**LICENSE AMENDMENT REQUEST TO CHANGE TECHNICAL SPECIFICATIONS IN
SUPPORT OF PRNM AND ARTS / MELLLA IMPLEMENTATION**

Columbia Generating Station Power Range Neutron
Monitoring System Design Analysis Report

**Columbia Generating Station
Power Range Neutron Monitoring System
Design Analysis Report**

Enclosure 1
DI&C-ISG-04 Compliance

Figure 1 - RBM Communication Links

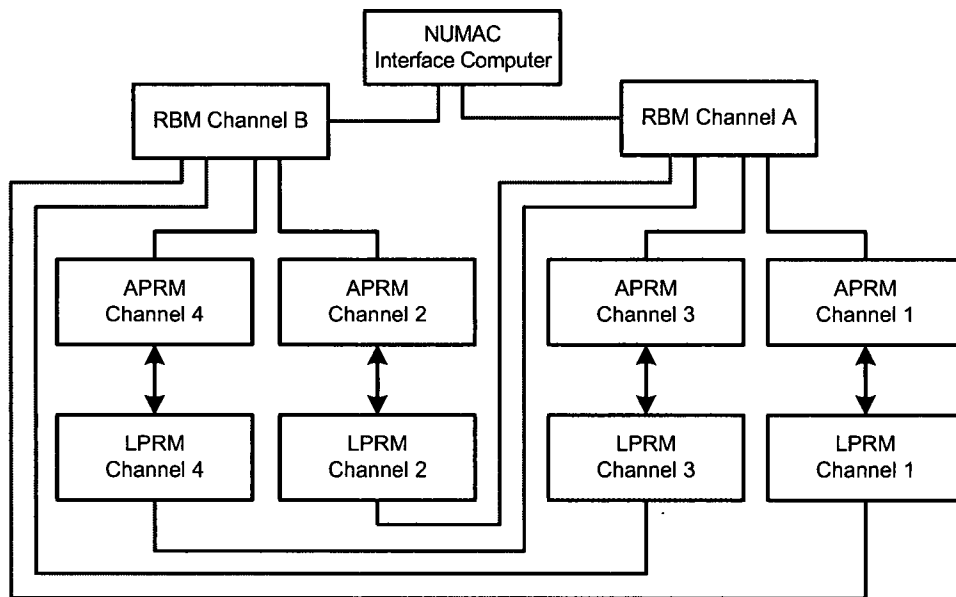
The interdivisional interfaces identified in the original NRC request pertained to the use of Power Range Communication Interface (PCI) modules which provide certain functionality

similar to that provided by the RBMs used within the CGS PRNM, but also provide additional functionality not found in the RBMs – nor required for the CGS PRNM.

The additional functionality provided by the four PCI modules – each dedicated to a single APRM channel – required interdivisional interfaces between those PCIs.

As shown in Figure 1, there are no communication links between the two RBMs used in the CGS PRNM, and therefore the concerns related to the interdivisional interfaces between PCI modules are not applicable to the CGS PRNM.
